GEORGIA DEPARTMENT OF COMMUNITY AFFAIRS

CODE AMENDMENT FORM

CODE: 2023 National Electric Code SECTION: Article 702.4(A)(2)

PROPONENT: Michael Hart (Tesla) DATE: 4/12/2023

Figure 2: Example flow of Automatic and Manual Backup modes that ensure the system does not get overloaded upon transfer

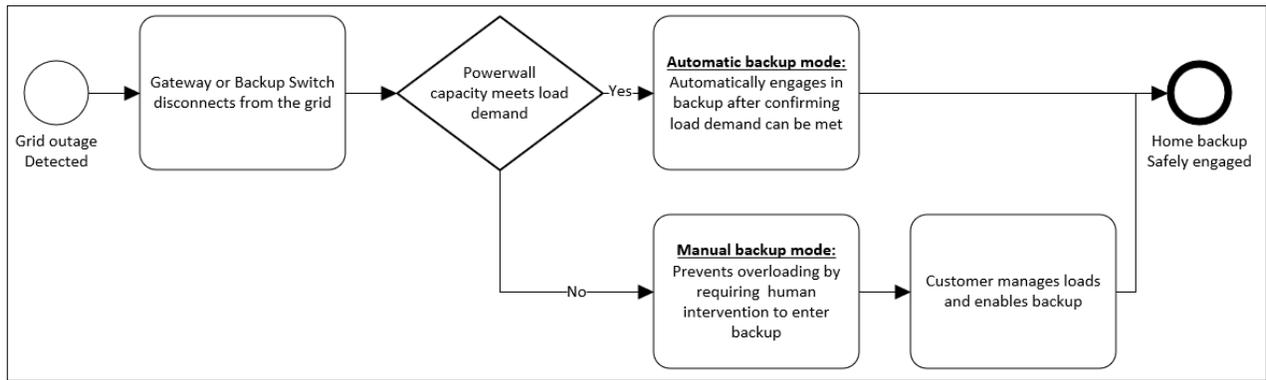
Tesla's Powerwall systems are engineered to safely manage load demand while providing the optimal home backup profile for our customers. The Powerwall achieves this through the following functionality.

- Real-time monitoring of the house electrical loads connected to the system
- In the event of automatic transfer, the system ensures it can back-up the connected load to prevent overloading
- If the load exceeds the Powerwall capacity, it prevents overloading by requiring manual transfer

Each system has a site-specific design to ensure that the Powerwall's output capacity is sufficient for any single load in the backup circuit. This, in combination with the features listed above, enables the customer to safely manage which loads they want to use during a grid outage. Flexible load management is important to customers as they experience unique grid outage events that often differ in length, severity, and circumstance.

Historically, Powerwall installations have used Article 710.15 for determining which loads can be included in the electrical back-up circuit. Over 90% of recorded outage events for these installations were backed up using automatic back-up mode. Meaning that the system ensured there is sufficient capacity, and rating, for real-time load demand when initiating automatic backup. In the instances where real-time load demand exceeds the available power, the Powerwall prevents overloading from occurring by entering a manual backup mode.

Figure 1, Typical Microwave Oven Circuit

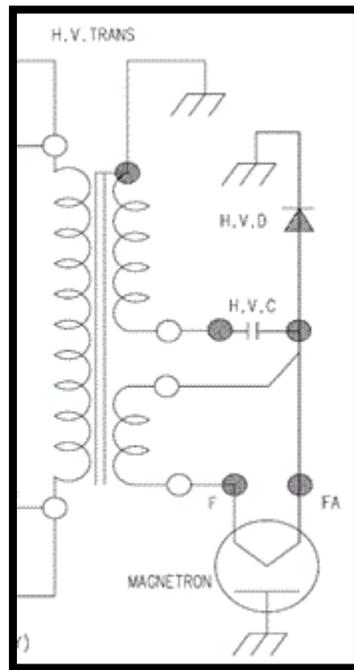
Microwave ovens are designed using a half-wave voltage multiplier circuit and magnetron in the power pack to implement basic functions that generate microwaves (see Figure 1).

Figure 2, Typical Microwave Oven Waveforms

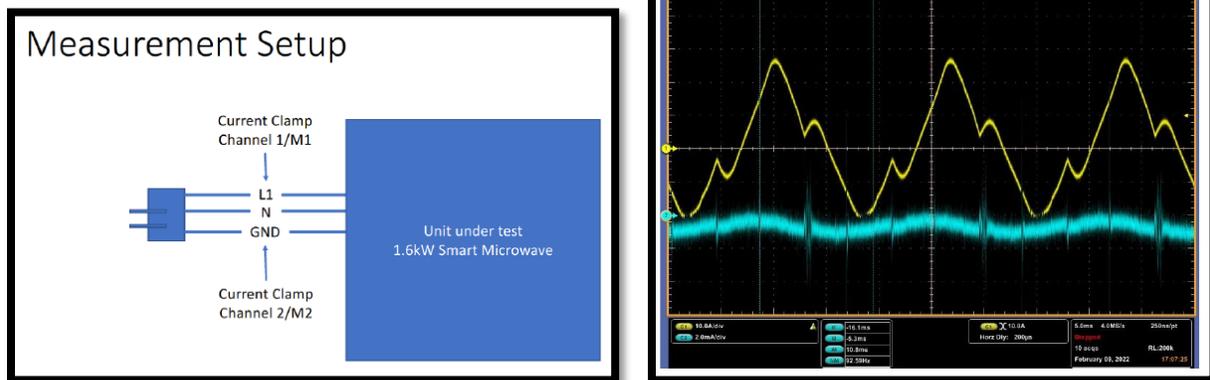
A microwave oven's normal operation thus creates non-sinusoidal, noisy, waveforms that may be mistaken for arc signature by present AFCI's trip algorithms (see Figure 2).

Until the AFCI designs and UL 1699/CSA C 22.2 #270 are updated to avoid nuisance tripping during normal microwave operation, microwave ovens should be excluded from the requirement of AFCI protection.
